Name of Proposed Subdivision CHANDLERS LANDING - PHASE 18-B

~~SITE/PLAN/PRELIMINARY/PLAT/FINAL~~ PLAT

Re: Second Review  
Chandlers Landing  
Phase 18-B  
ROK 84834

re: Third Review  
Chandlers Landing, Phase 18-B  
ROK 84834

FINAL PLAT  
CHANDLERS LANDING  
PHASE 18 - INSTALLMENT 2

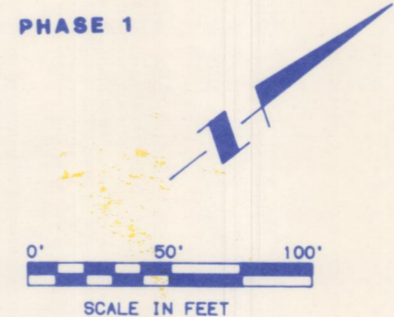
1. Engineering approval
2. Rename to Phase 18, Installment 2
3. Add location map
4. Reduce to 18" x 24"
5. List acreage at end of field notes
6. Label front setbacks
7. Enlarge all utility easements to 15 ft.
8. Mark all utility easements in greenbelts
9. Change name of Challenge Circle to Constellation Circle
10. Label which side of lot is zero setback

This has been done on the title page and in the title block on all drawings and plats.

A vicinity map is included on the title page showing the location of Chandlers Landing, Phase 18, Installment 2.

The plat has been reduced to a sheet size of 18" x 24".

The acreage of Chandlers Landing, Phase 18, Installment 2 has been calculated and added at the end of the field notes on the plat.

The front setbacks have been labeled. The general setback line is 20 feet from the property line; However, some of the front property lines are very short and the City of Rockwall regulations require that the setback line be at least 40 feet long. For this reason, several of the lots require an extra deep setback line to allow the setback line to be a full 40 feet long. These particular lots are noted on the plat.

All utility easements have been enlarged to a minimum of 15 feet. The front setback line on all lots is also a utility easement and it is a minimum of 20 feet.

All greenbelts which are used as utility easements are now so labeled on the plat.

This name change has been accomplished.

The side of each lot to be used for 0 setback has been noted on the plat.

PAVING PLAN  
 CHANDLERS LANDING  
 PHASE EIGHTEEN-INST. 2

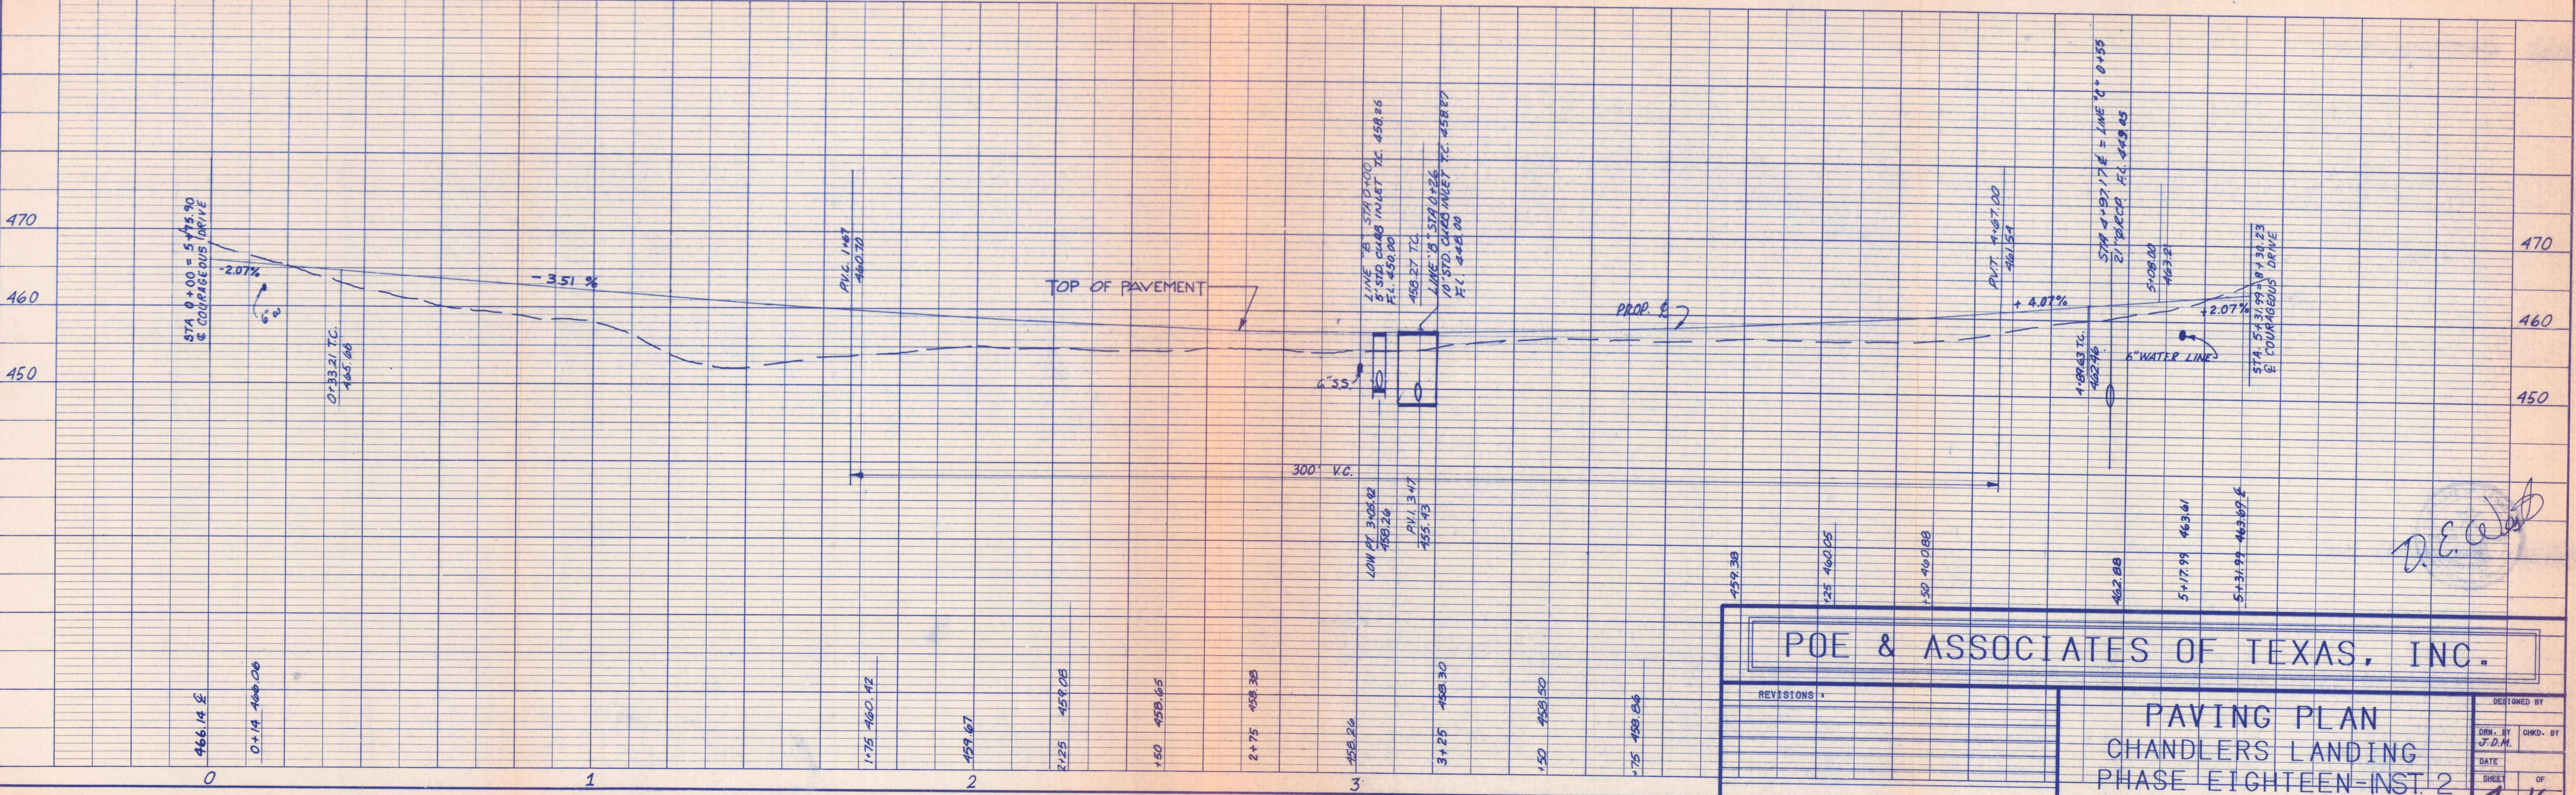
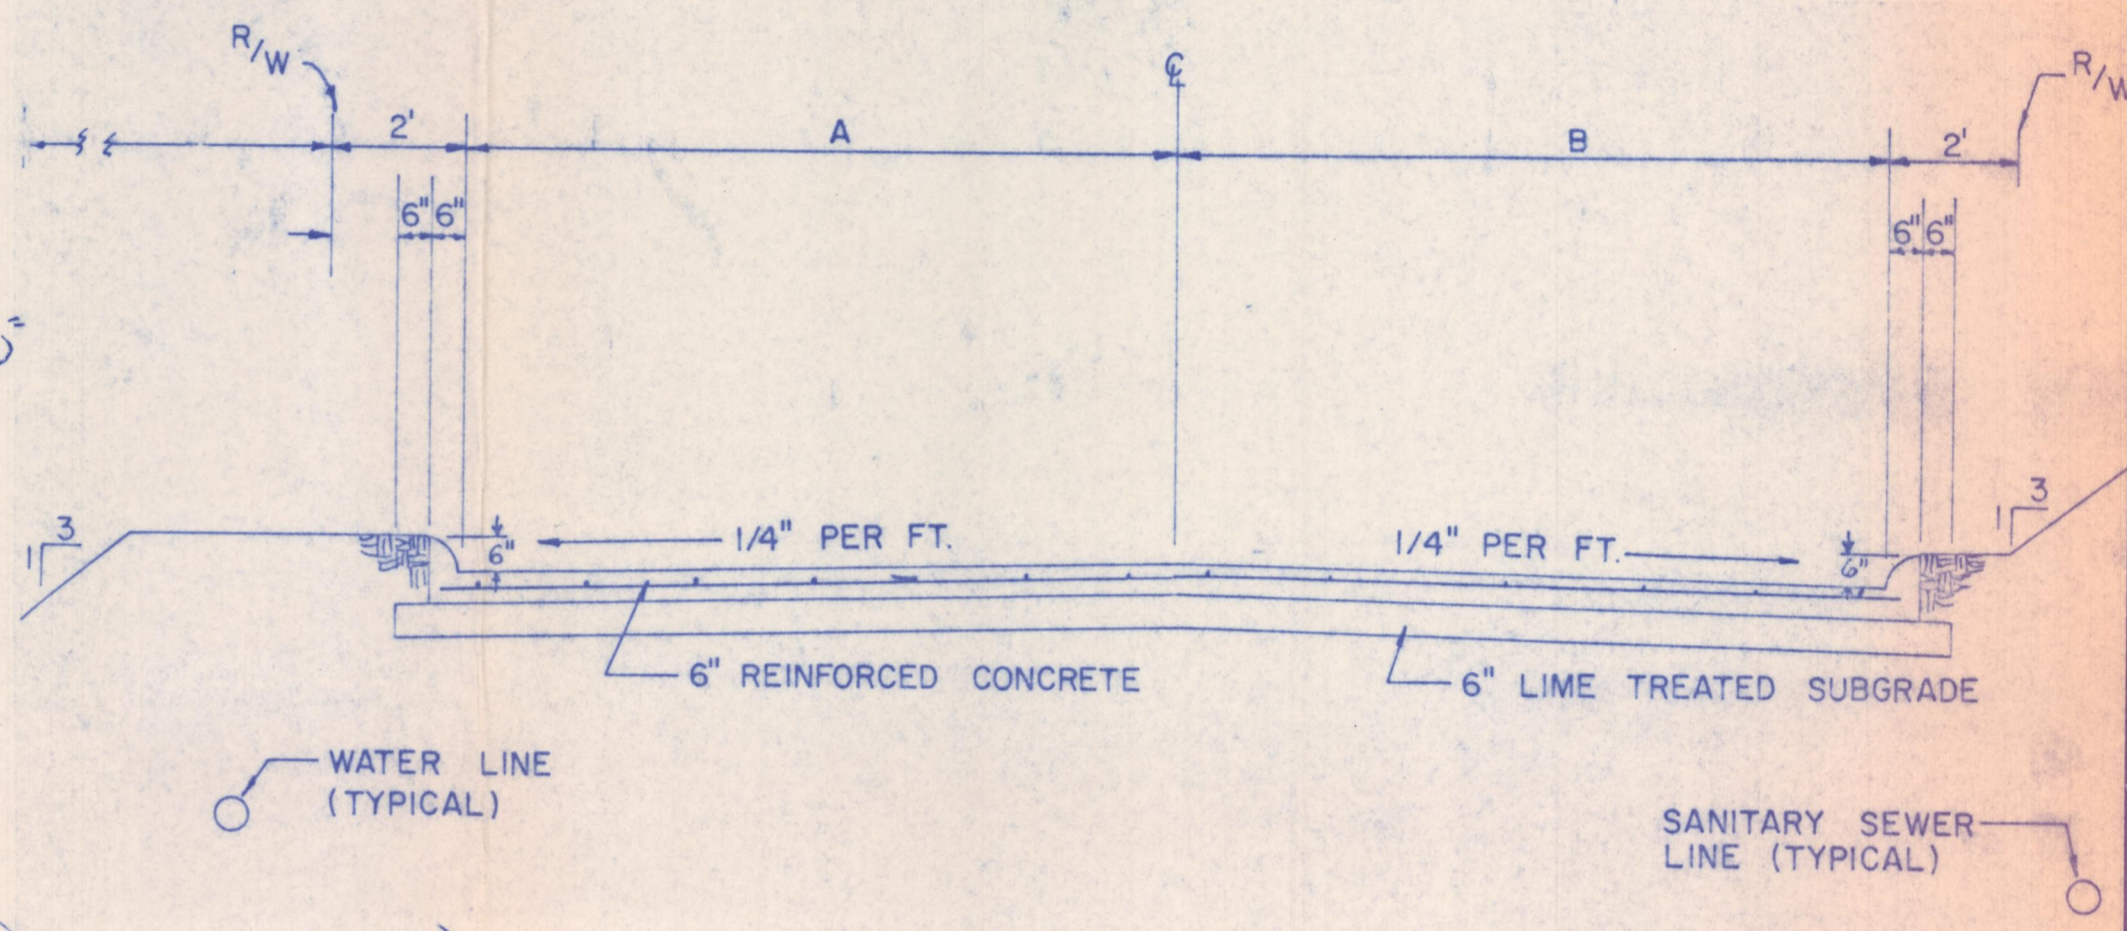
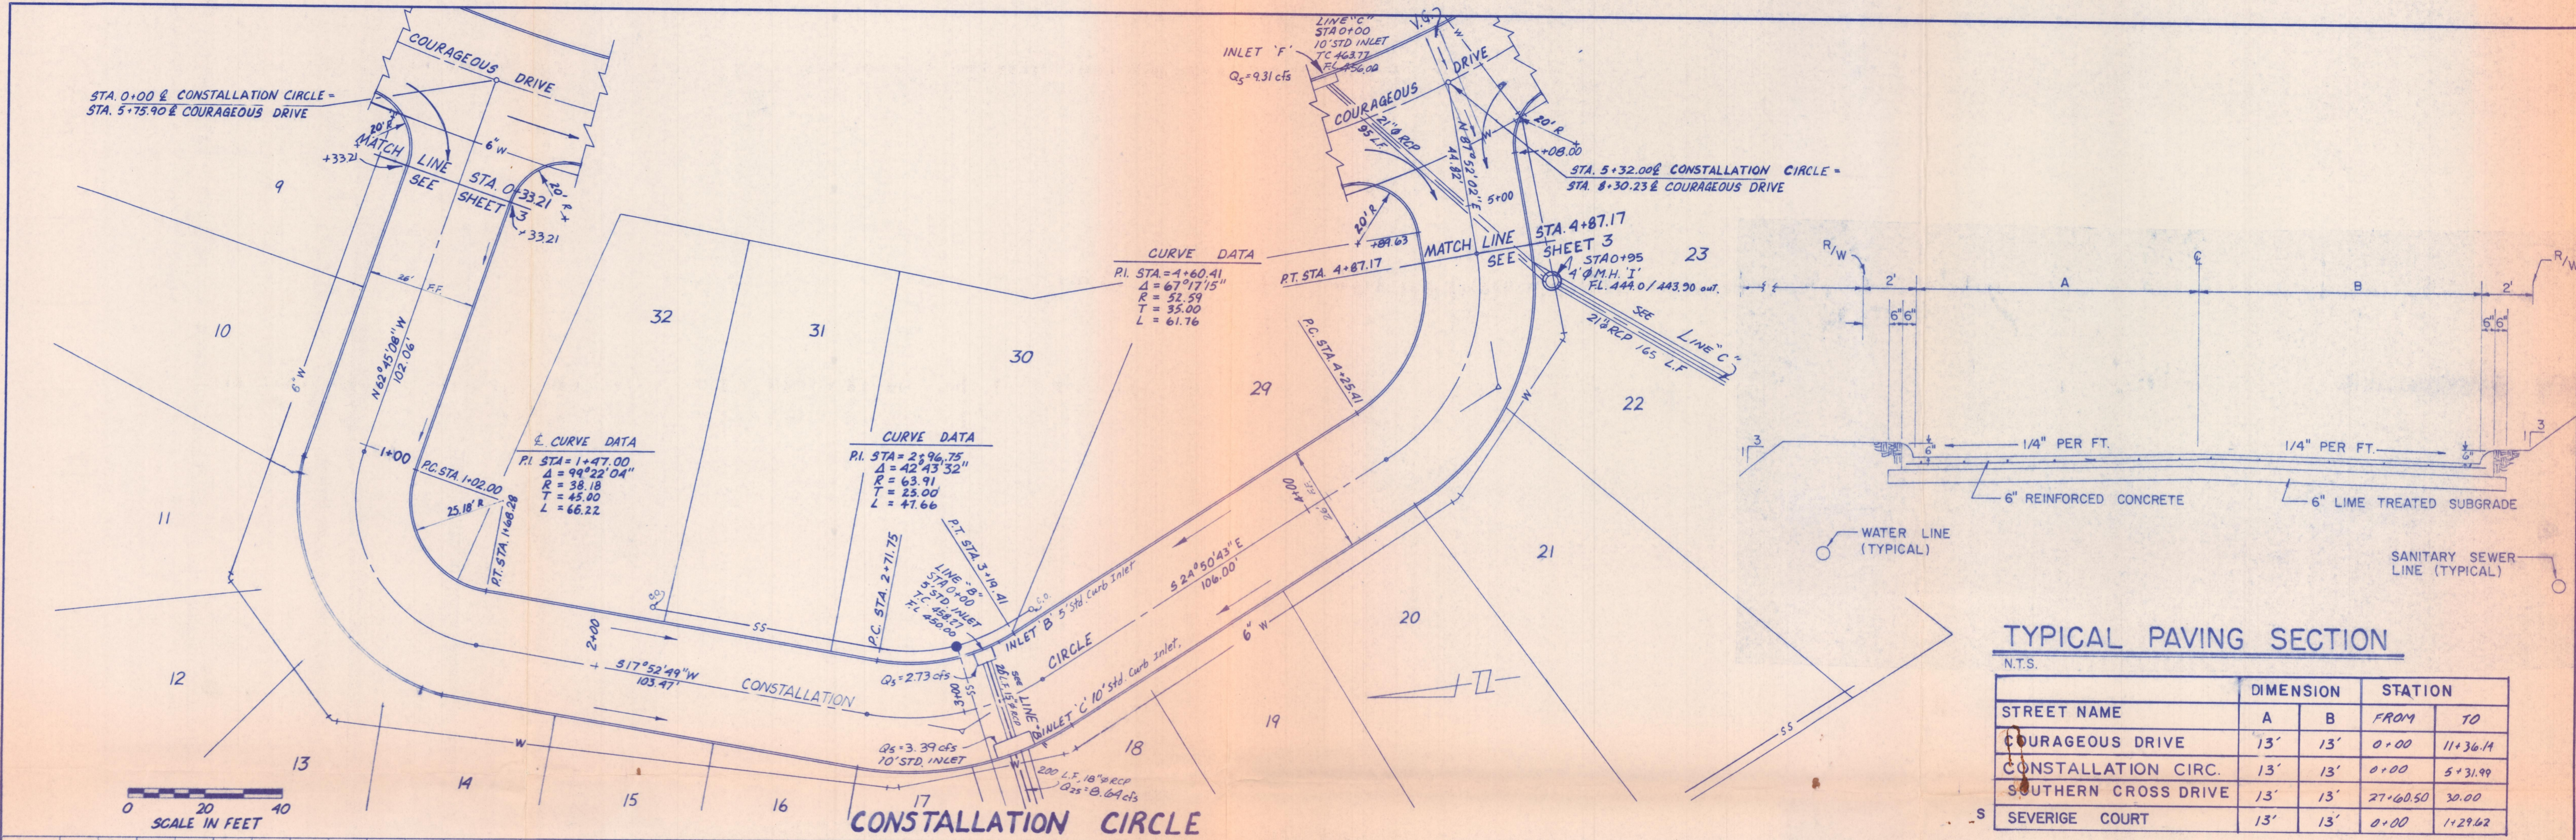
SHEET 4 of 15

A renamed Constellation Circle. Since this circle is very short and vehicular velocities would be very limited, it is respectfully requested that the curves of less than 150 foot radius be allowed to stand, since an increase in the radius of any of these would adversely affect the lots bordering on this circle. This is a planned development.
